Application Reference: 240689

Address: Richfield Driving Range Ltd Richfield Avenue Reading RG1 8EQ

Proposal: Application for approval of details reserved by condition 12 (External Lighting) of Application 212061

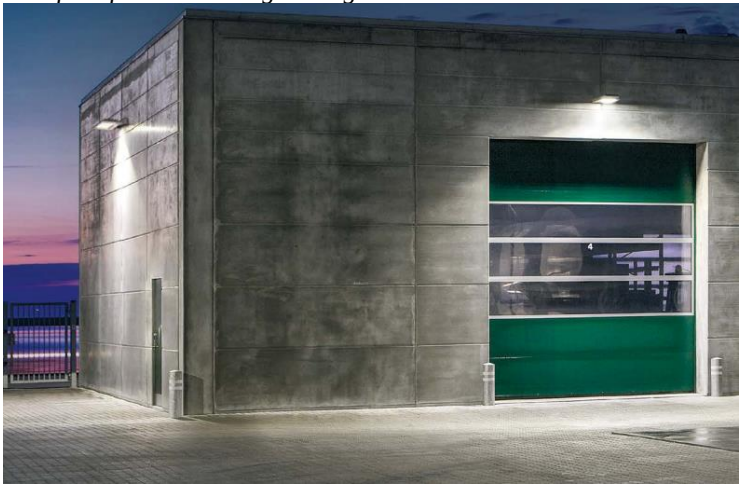
For added clarity you then provided the following information:

All luminaire types and locations can be easily seen on drawing FS0949-DBS-XX-XX-DR-E-9020_C01 and external lighting calculations document FS0949-DBS-ZZ-ZZ-CA-E-0002_C01 (All snips added below). Please see snip from drawing FS0949-DBS-XX-XX-DR-N-9020_C02, with the note from 'External M&E service legend' below:

North façade Z1B – Yellow, Z5B - Green

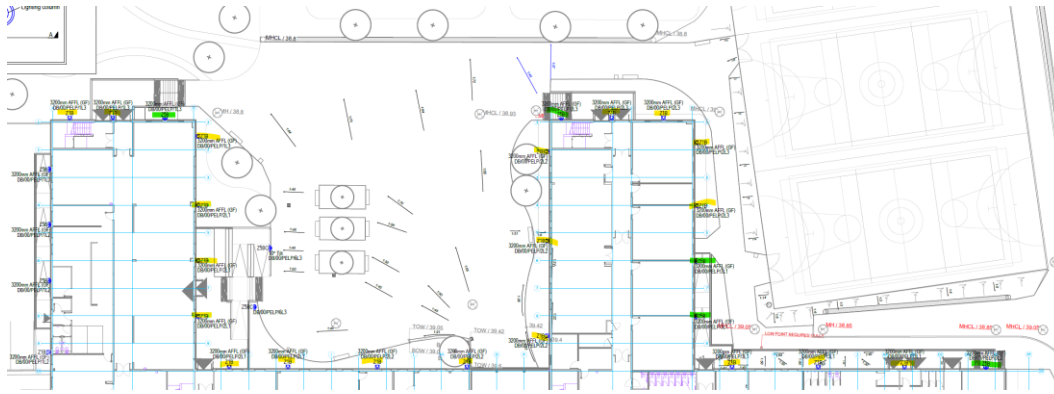
The Council's environmental protection team sought further information and confirmation of lighting, particularly for the north facing façade and area. You were able to provide replies as follows:

On the facades we have type Z1B & Z5B fittings: Example of Z1B mounting and light distribution

Example of Z5B mounting and light distribution

All this information has now been considered and it has been confirmed that the information provided satisfies the requirements of this condition. Thank you doing this and for allowing the added time to deal with this application to achieve this position.
